Summit Homes
120 SE 30th St.
Lee's Summit, MO 64082

RE: Field Issue of non-continuous floor joist and girder truss bearing for Lot # 159 Hawthorne Ridge – 3104 SW Arboridge Dr. Lee's Summit, Mo 64082 – Permit # PRRES20212709

Support for GT Bearing at SW corner of garage.

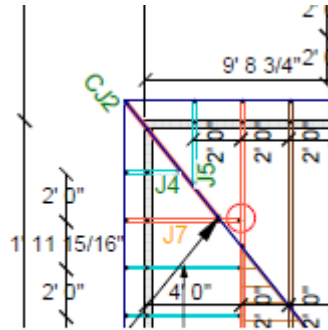
- Girder truss J7 max gravity reaction is 268 #.
 - **Girder truss J7 shall be supported by Douglas Fir Larch #2 2x4 stud wall @ 16" oc.**
